**FAO:** An Bord Pleanála

**Case Number:** 305982 (Strategic Housing Development)

**Applicant:** Glenveagh Living Limited

**Development Description:** Development of 332 no. apartments, a creche and all associated site works.

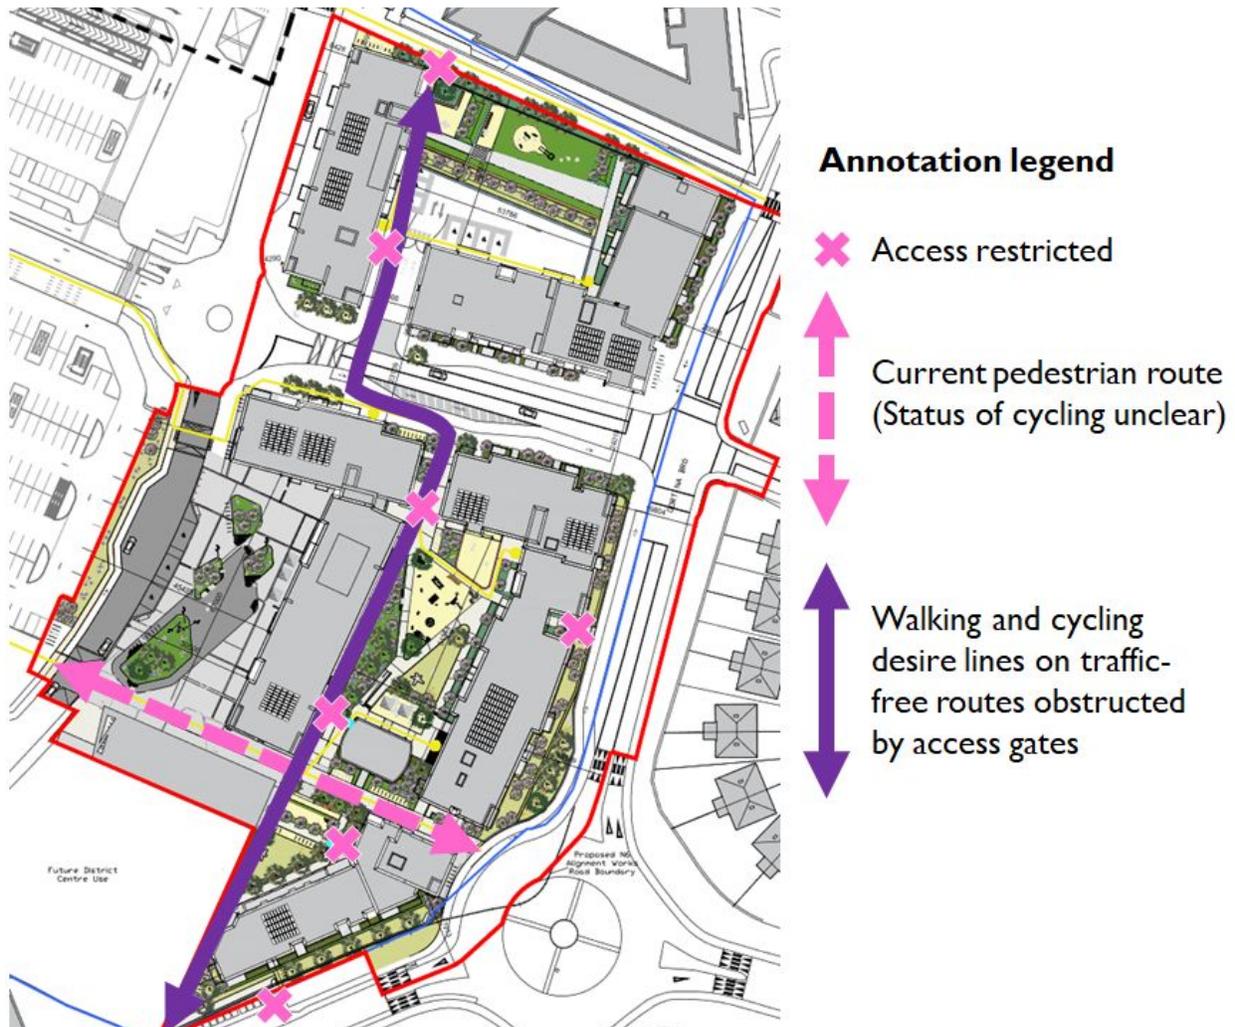
Cycling and walking links through this development appear to be lacking. We have identified only a single through pedestrian route through the site, and there are no apparent cycling routes through the development.

Drawings indicate controlled access gates giving 24-hour access to residents at various points on the perimeter and the interior of the development. It is unclear whether these will be open for restricted times for access to the general public.

**Recommendation:** *The proposed development needs greater connectivity via traffic-free walking and cycling routes through the site which is in accordance with national and local planning standards. Any private links should be designed to facilitate cycling for residents also.*

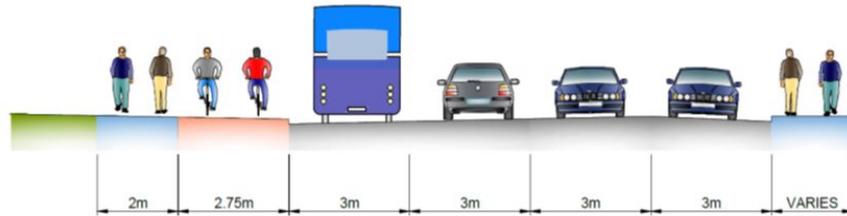
The use of two-way cycle tracks in the context of this development involves the insertion of random sections of two-way cycle track into the network in a manner that is not coherent and is not carefully managed. Their use in this context does not take account of the wider network design which involves one-way cycle tracks on each side of the road. This creates a risk that persons will start cycling from this development using a cycle track of one type and then move to using other cycle tracks to cycle on the wrong side of the road - because the design will make this the most obvious option.

For example these fragments of two-way cycle tracks are used in a manner and location that could result in people on bikes feeling directed to circulate a roundabout in an anti-clockwise rather than clockwise direction. Roundabouts are already a junction type that carries high-risk of collisions for two-wheelers.

- *The proposed two-way cycle tracks create a fundamental and haphazard design change within a short section of the overall network in a manner that could encourage behaviours associated with substantial increased in the risk of junction collisions.*
- *The proposed two-way cycle track is much too narrow given its context and is not in accordance with national best practice.*
- *The design legibility is poor to enter and exit the contra-flow aspects of the two-way cycle lane, and relies on cyclists either dismounting and transitioning at zebra-crossings or cycling across them illegally.*
- *The best option would be to remove two way cycling facilities in favour of cycle tracks on either side of the road with the direction of traffic. This should however be coherent with the overall context including junction layouts and alternative traffic-free routes nearby.*

**Figure 3.a** Cross-sections provided from drawing HT0102 “General Arrangement”. Both indicate a two-way cycle-track of 2.75m.

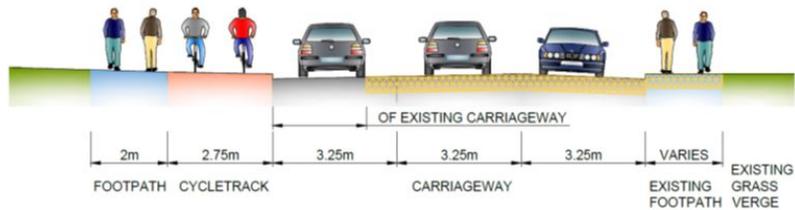
We note that the proposed two-way cycle lanes are 2.75m wide. Given the location near a school and the general traffic environment, this is insufficient.

**Figure 3.c** Extracts from HT0102 “General Arrangement” annotated with the anticipated “contra-flow” routes (green lines in direction of arrow). The only feasible transition areas to enter

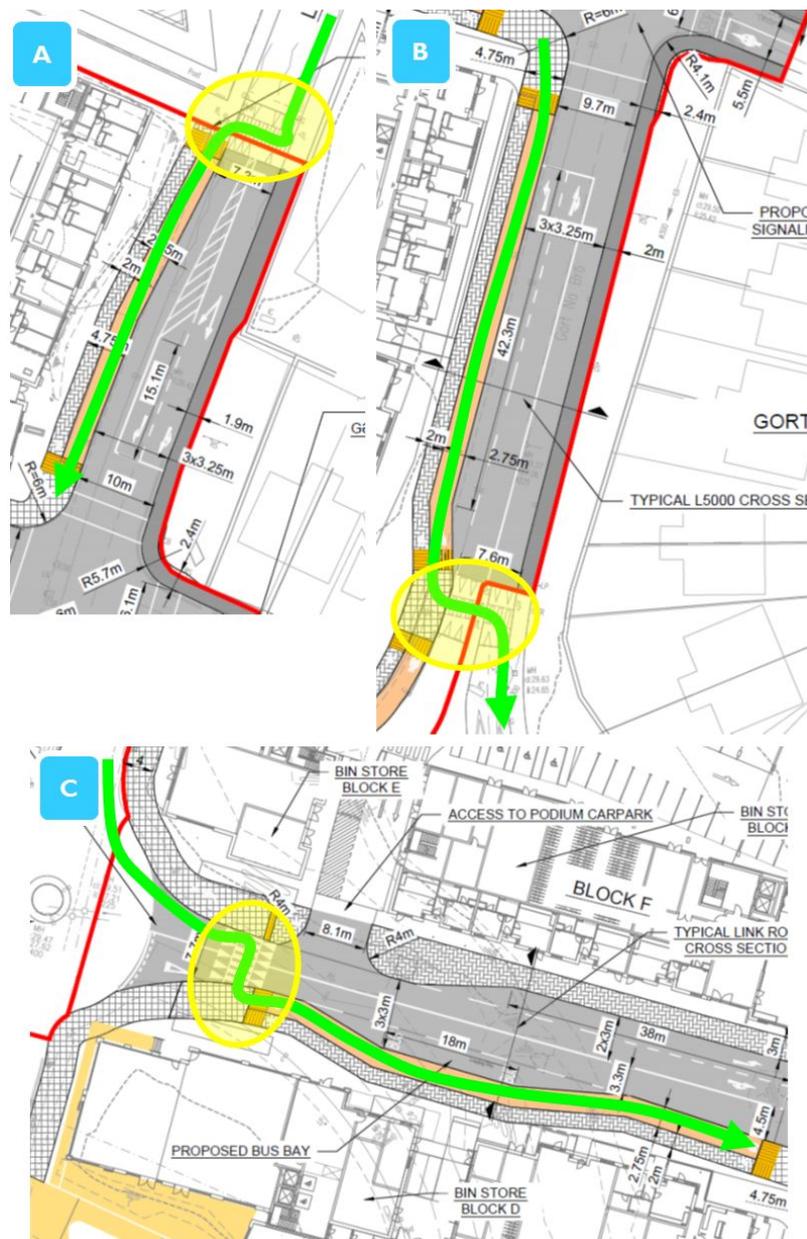
Furthermore, there is little apparent “design legibility” for how those wishing to access/egress for contra-flow cycling should do so.

Zebra crossings are a type of signalised pedestrian crossings which people on bicycles are not legally allowed to use. There is also an apparent underlying assumption that cyclists will use zebra-crossings to transition to the roadway to enter or at the end of such contra-flow sections. It is unclear whether the designer of this scheme expects cyclists to either dismount and walk or cycle to cross these. The former approach directly undermines the coherence and convenience of cycling, key requirement of any valid transport mode. The latter is illegal. A design which gives people cycling only these two options to make progress is patently a poor one.

the contra-flow (panel A and C) and to exit the contra-flow (panel B) are given at zebra-crossings. Given it is not legal to cycle on zebra-crossings, the implication is that cyclists must dismount to transition to/from any contra-flow cycle lane.

**Figure 4.a** Extract from drawing HT0102 “General Arrangement” with section of on-road cycle lane within the Gort na Bró roundabout indicated within dashed-blue area.

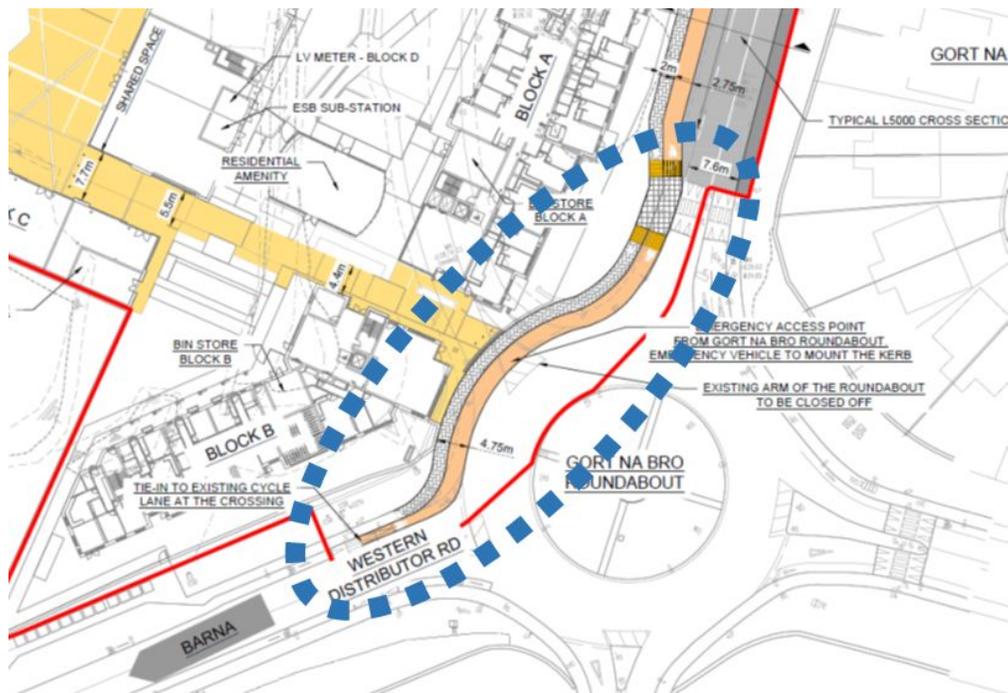
We note with concern that an apparent two-way cycling facility (or one tied directly into a two-way cycle track) has been placed within the circulating section of the Gort na Bró roundabout, in the proposed design - see Figure 4.a. It is not clear whether this is a raised cycle track or a painted, on-road cycle lane. In either case, this has the effect of encouraging/pressuring cyclists taking the second or later exits (travelling straight-ahead or turning right) to expose themselves to “left-hooks” by motor vehicles. The design also creates the possibility that people on bikes will feel directed to continue their wider journeys by circulating the roundabout in an anti-clockwise direction.

We anticipate also that traffic volumes on this multi-lane roundabout are already far in excess of the 6,000 vehicles per day criterion for segregation at this location. We also recommend that the arms of the Gort na Bró roundabout within the bounds of this development be reduced to a single lane. Referring to relevant sections of the National Cycle Manual:

- *The proposed cycling facility within this section of the Gort na Bró roundabout should be removed, in accordance with national and international best practice.*
- *An alternative traffic-free route in the design should be identified and provided for people cycling from the Western Distributor Road heading northwards, particularly children travelling to Gaelscoil Mhic Amhlaigh. This route should run through the development and be fully separated from the roundabout and the unnamed L5000 road to be redesigned.*
- *The Gort na Bró roundabout should be reduced to a single lane entry for all arms within the scope of this development, again in line with the National Cycle Manual.*

**Figure 5.a** Extract from drawing HT0102 “General Arrangement” with section of

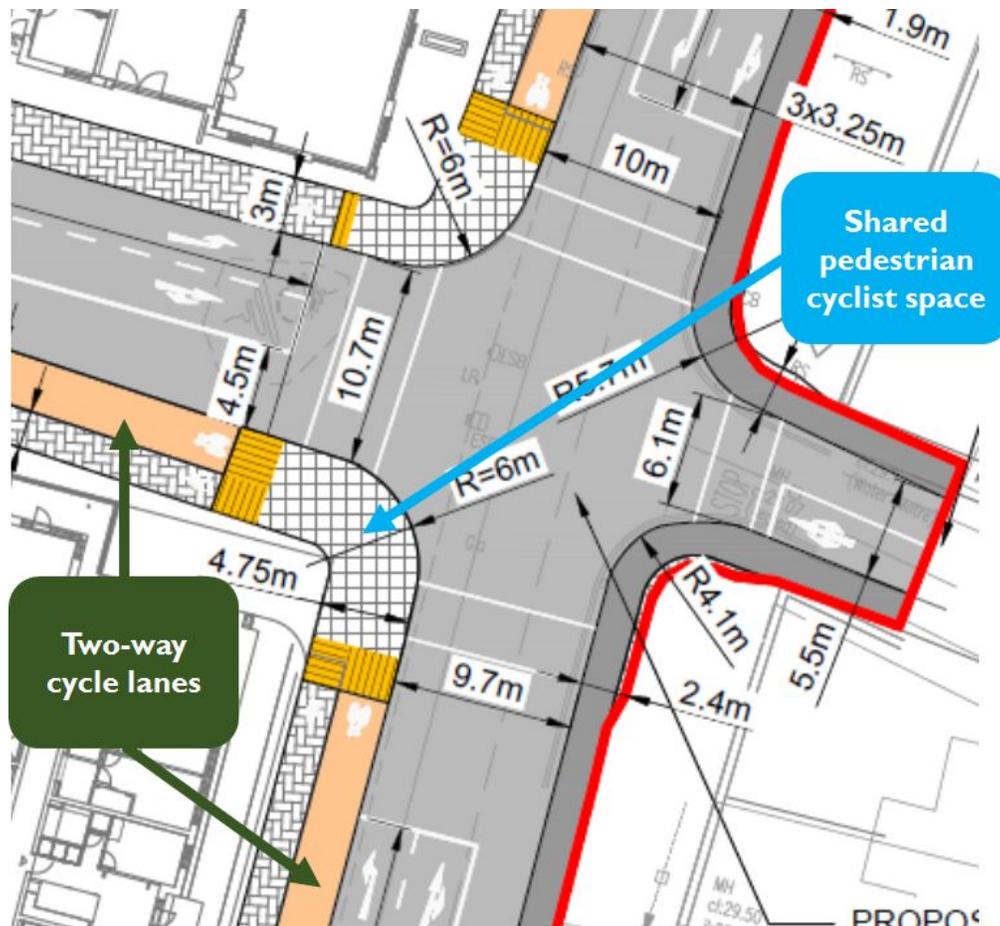
We note that a key feature at the proposed signalised junction is for two-way, raised cycle tracks to terminate at shared space areas at signalised junctions. This will create unnecessary conflict between people walking and cycling, and result in children cycling and walking to and from school, in addition to others cycling and walking in both directions being squeezed into a relatively narrow area.

This guidance is clear; shared space especially in areas such as this should be avoided if possible. This issue is exacerbated by the presence of cyclists travelling in both directions on such shared space. Furthermore, as pedestrians and cyclists will be gathering on this relatively small area of junction to cross at toucan crossings, queueing will be haphazard, and it is possible there will be overspill at busy morning periods. The cross-section of shared space on the north-western arm of the junction is only 3m which is clearly inadequate for such a purpose.

- *The proposed design for shared space at the signalised junction in this development is inferior for both walking and cycling and should be removed.*
- *Alternative junction configurations which ensure the safety and convenience of walking and cycling should be used.*

**Figure 6.a** Extract from planning application drawing showing use of unsuitable and narrow lane widths at the new link road junction.

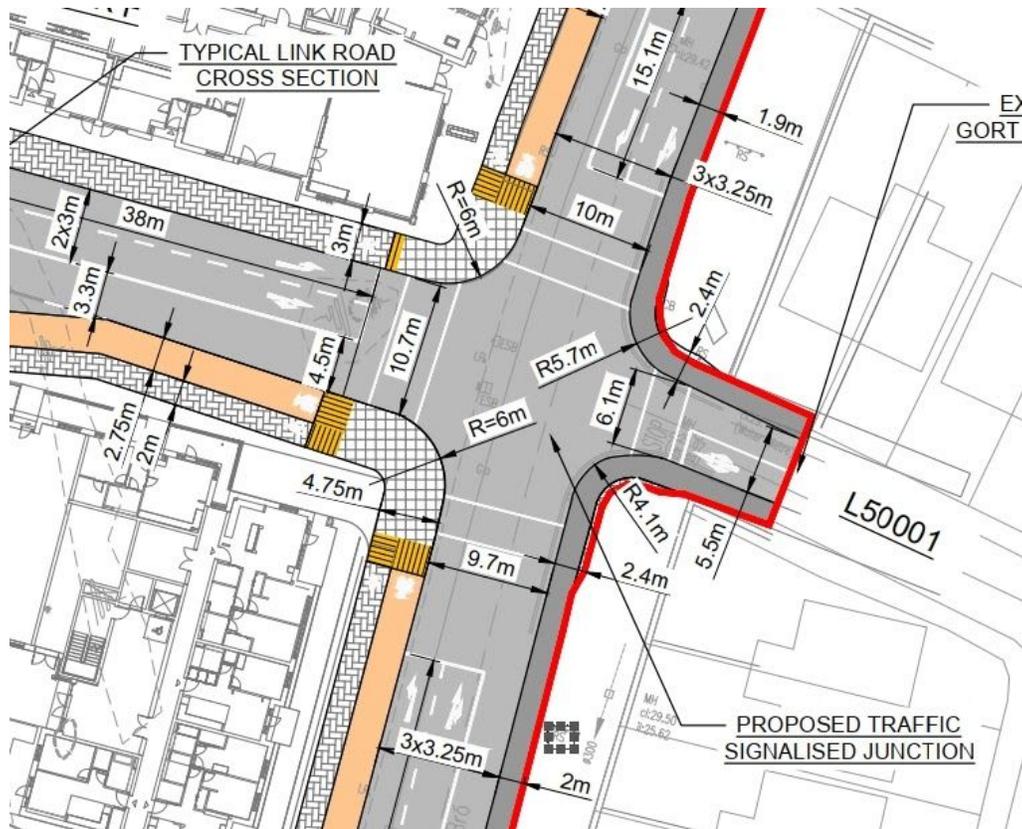
We note that the treatment of the lanes at the proposed junctions indicate a lane widths of 3.25m or less. But in several cases no separate space is provided for cycling.

At the proposed traffic signals at Gort Na Bro the following lane widths are seen.

North Arm - 3 x 3.25m lanes

East Arm - Gort Na Bro - 5.5m total so 2 x 2.75m

South Arm - 3 x 3.25m lanes

West Arm - exiting lane starts at 4.5m going west narrowing to 3.5 - entering lanes are both 3m

This does not comply with long established best practice.

- *Reduced traffic lane widths are unacceptable without (1) provision of segregated space for cycling, or (2) reduction in the volume of motor traffic via removal of through motor-traffic.*
- *If cycle facilities are not being provided roads elsewhere in this development use lane widths of 4.6m and these work quite well for cyclists provided traffic speeds and volumes are kept low. This standard should be kept for safety and convenience of cycling.*
- *Any cycling facilities should be of a sufficient width and be part of a coherent network for cycling, including junction treatments.*
